# HISTORIC AND DESIGN REVIEW COMMISSION

January 19, 2022

**HDRC CASE NO:** 2021-612  
**ADDRESS:** 2043 W SUMMIT AVE  
**LEGAL DESCRIPTION:** NCB 1942 BLK 30 LOT 11  
**ZONING:** R-6, H  
**CITY COUNCIL DIST.:** 7  
**DISTRICT:** Monticello Park Historic District  
**APPLICANT:** Louanne (Ann) Hardee/HARDEE CHARLES R & LOUANNE  
**OWNER:** Louanne (Ann) Hardee/HARDEE CHARLES R & LOUANNE  
**TYPE OF WORK:** New construction of a rear accessory structure  
**APPLICATION RECEIVED:** January 07, 2022  
**60-DAY REVIEW:** Not applicable due to City Council Emergency Orders  
**CASE MANAGER:** Rachel Rettaliata

The applicant is requesting a Certificate of Appropriateness for approval to construct an accessory structure in the rear yard.

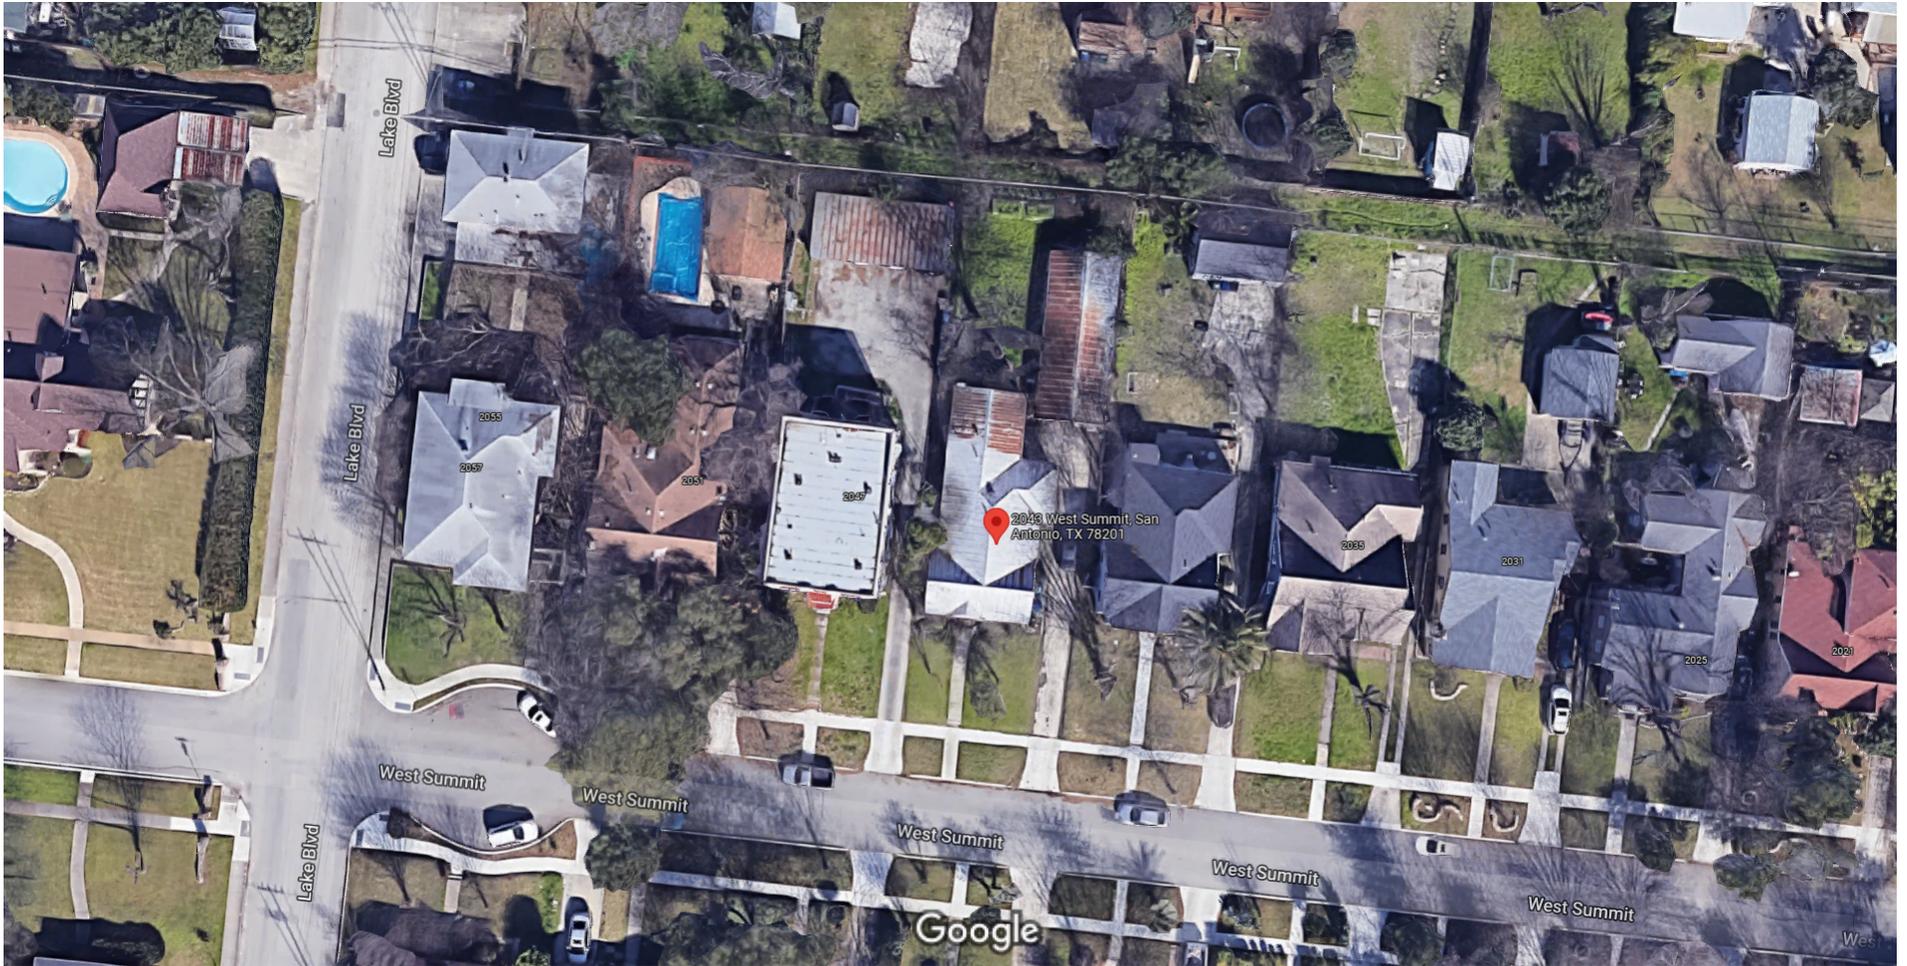
- c. **NEW REAR ACCESSORY STRUCTURE: ORIENTATION** – The applicant has proposed to install a 36-foot by 20-foot front gable steel accessory structure with attached carport on the replacement concrete slab at northeast side of the property, in the same location as the previously existing rear accessory structure. The proposed rear accessory structure will be oriented toward W Summit, matching the orientation of the previous accessory structure. Guideline 5.B.i for New Construction states that applicants should match the predominant garage orientation found along the block. Do not introduce front-loaded garages or garages attached to the primary structure on blocks where rear or alley-loaded garages were historically used. The applicant has

provided evidence that the proposed structure will match the predominant orientation on the block. Staff finds the proposal appropriate.
